WATTS BAR NUCLEAR PLANT (WBN) - CHANGES TO FINAL SAFETY ANALYSIS
REPORT (FSAR) CHAPTER 8 TO RESOLVE AMENDMENT 90 ISSUES

The enclosure is a set of marked up pages from FSAR Sections 8.2.1.8, 8.2.2, and 8.3.1.4.3. The markups provide clarifications to resolve three basic issues identified in the NRC staff review of Amendment 90:

PROPOSED CHANGES TO
FINAL SAFETY ANALYSIS REPORT (FSAR)
SECTIONS 8.2.1.8, 8.2.2, AND 8.3.1.4.3

HYDRO & STEAM POWER STATIONS
 WIRING DIAGRAMS
 DEVELOPMENT SINGLE LINE
 TVA DWG NO. 45N501 R27
 FIGURE 8.2-1A

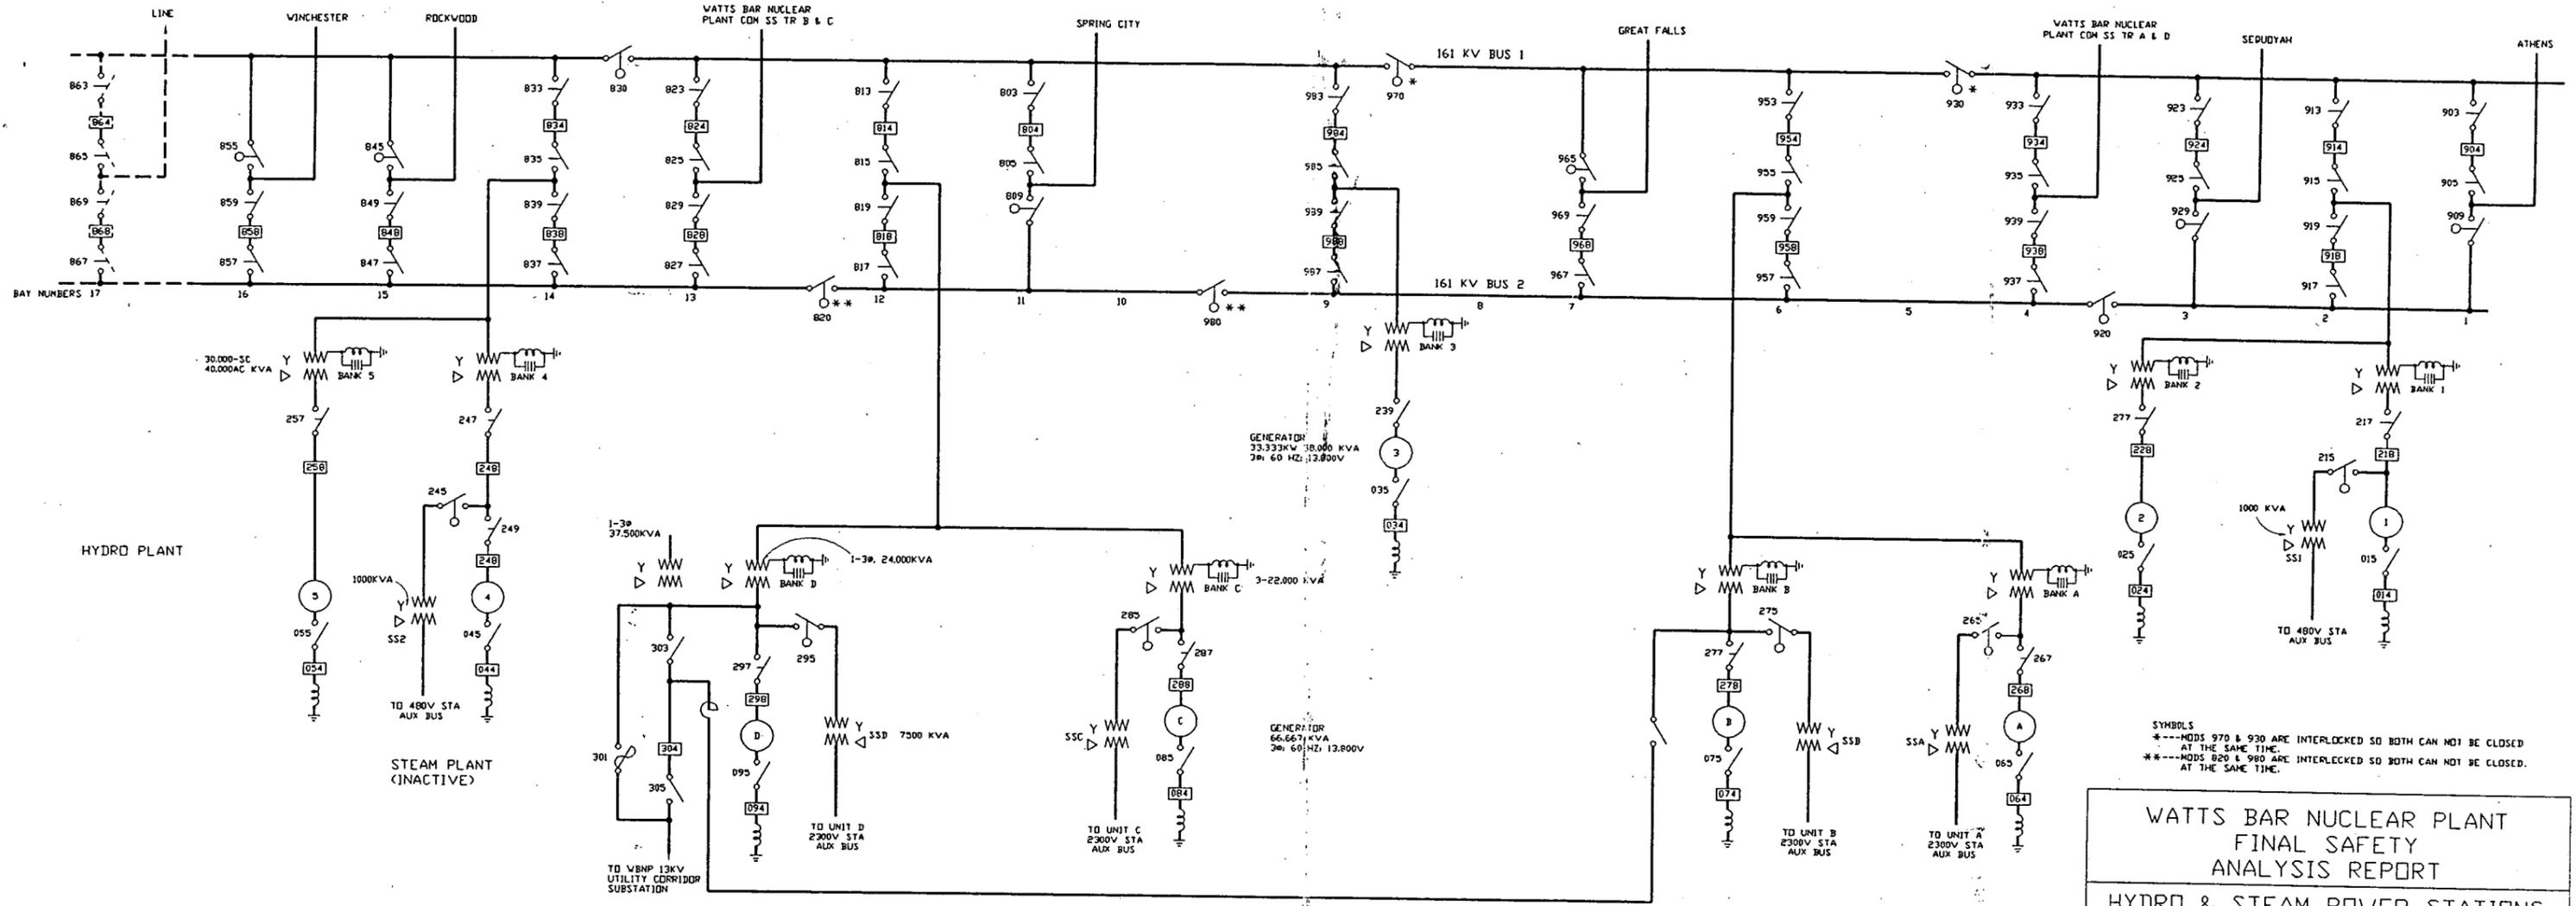
In addition, enclosed is a draft of Figure 8.2-1A which corrects minor drawing errors that involved duplicate equipment numbers for breakers and disconnect switches.
